<b>Subject:</b> <b>LACK OF POWER / WRENCH LIGHT ON / CHECK ENGINE LIGHT ON WITH DTCs P0123 / P0222</b>	<b>Bulletin No:</b> 01-012/15 <b>Last Issued:</b> 06/17/2015
-----------------------------------------------------------------------------------------------------------	-----------------------------------------------------------------

- This bulletin supersedes the previous bulletin 01-017/13, issued on 07/02/13. The **REPAIR PROCEDURE** and **WARRANTY INFORMATION** have been revised.
- Changes are noted below in Red beside the change bar.

2011-2013 CX-9 with VINs lower than JM3TB\*\*\*\*\*419830 (produced May 1, 2013)

### **DTC: P0123:00 TP Sensor No. 1 Circuit High Input.**

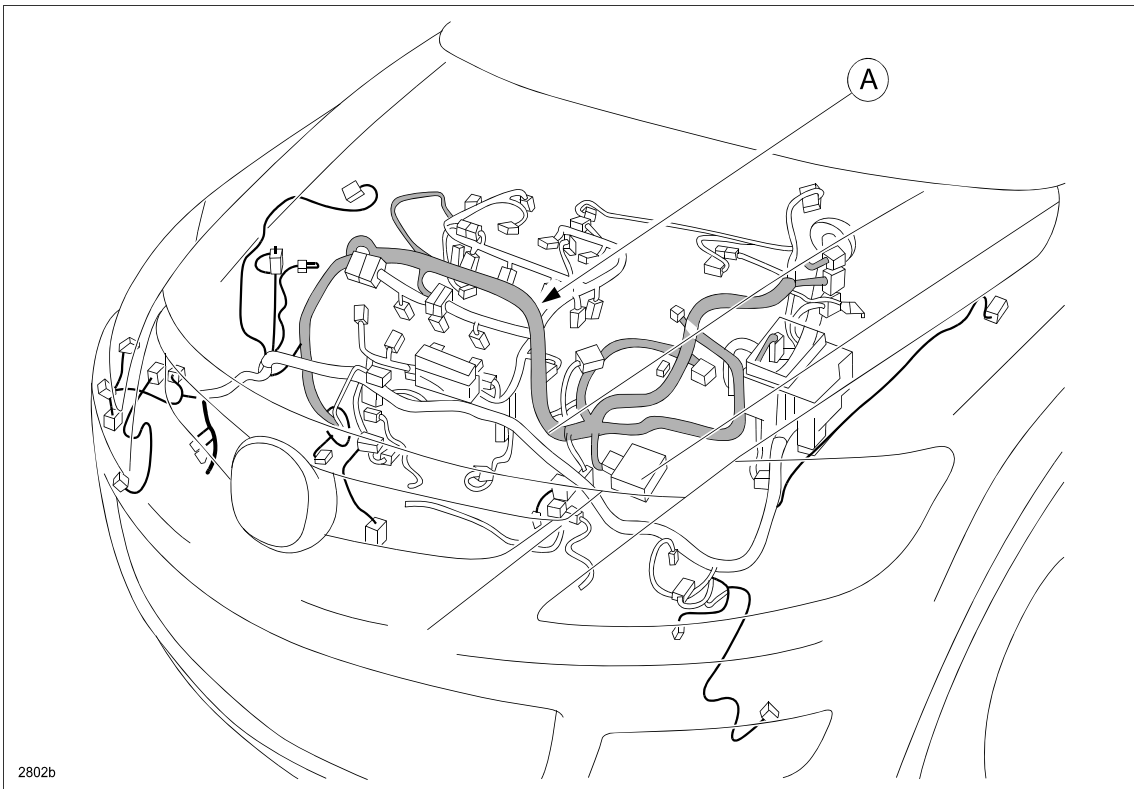
The TP sensor No.1 circuit was flagged as a concern by the PCM indicating a high voltage.

- Connector or terminal malfunction.
- Short to constant voltage supply circuit between throttle body terminal F and PCM terminal 2AN.
- TP sensor signal circuits are shorting each other.
- TP sensor No.1 malfunction.

If no trouble is found during the inspection above, replace the emissions harness (A) with a modified part.

**Emissions Harness Modification (2011 CX-9 Only):**

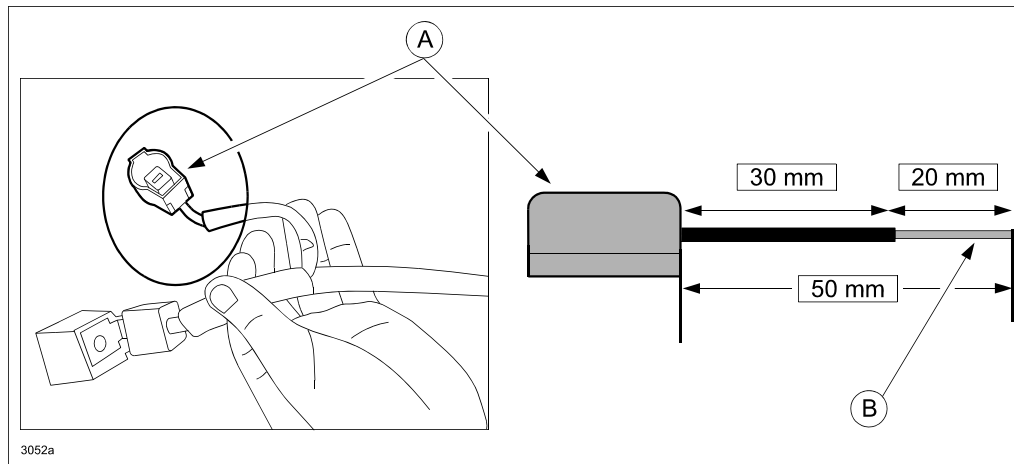
Since the shape of the “S” (starter) terminal in the 2011 CX-9 is different than later models, the new (modified) emissions harness (p/n: TG20-67-020C) cannot be used as is. It must be modified.

Follow the steps below to modify the new harness using the connector for the “S” terminal from the original harness:

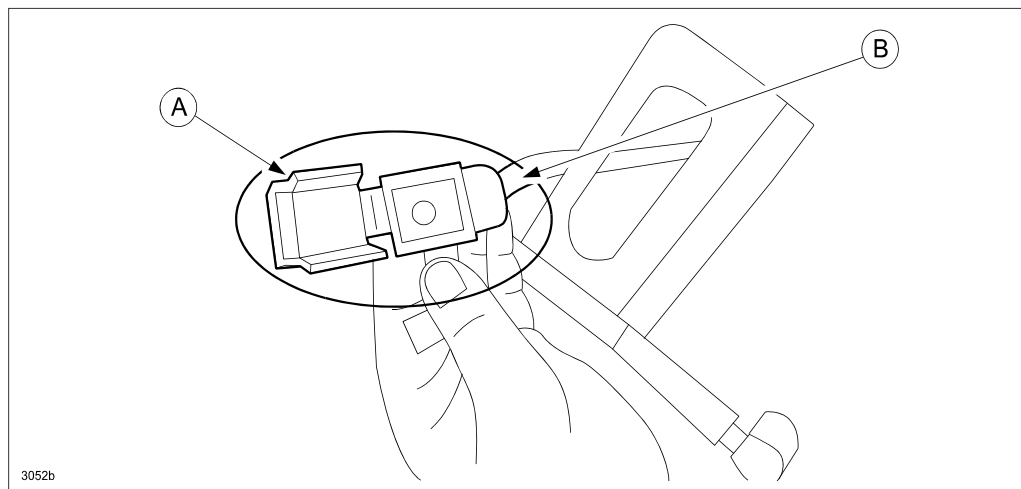
1. **Original Emissions Harness:** Cut the original harness 50 mm from the end of the connector (A).
2. Strip 20 mm of insulation from the end of the wire (B).

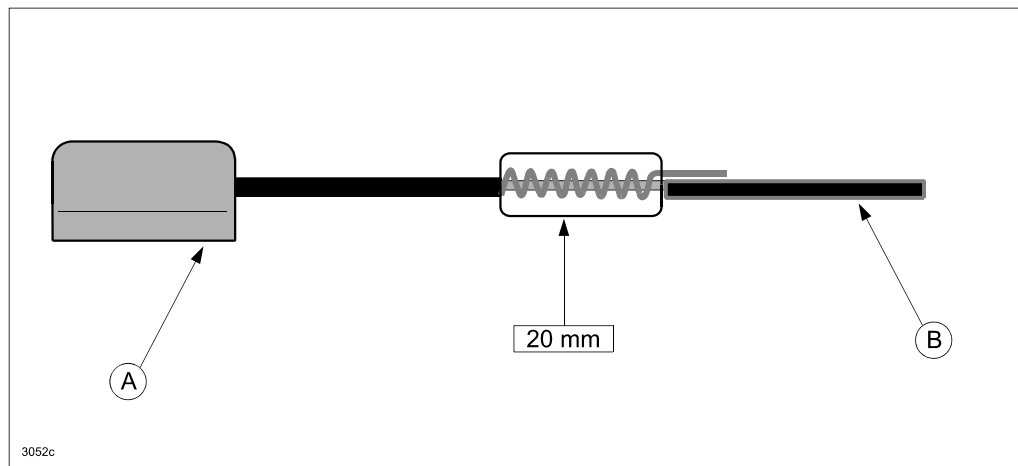
3. **New (Modified) Emissions Harness:** Cut off the existing connector (A) near the “S” terminal (B).
- NOTE:** Discard the connector.

4. Solder the connector wire from the original emissions harness (A) to the wire from the new modified emissions harness (B) as shown below.

5. Insulate the soldered wires with butyl tape, then again with electrical tape (over the butyl tape).  
**NOTE:** For additional information, refer to MS3 online (section 00-00 REPAIR-USE CONNECTOR REPLACEMENT PROCEDURE).
6. After completing harness replacement, clear the DTCs.
7. Verify the repair.
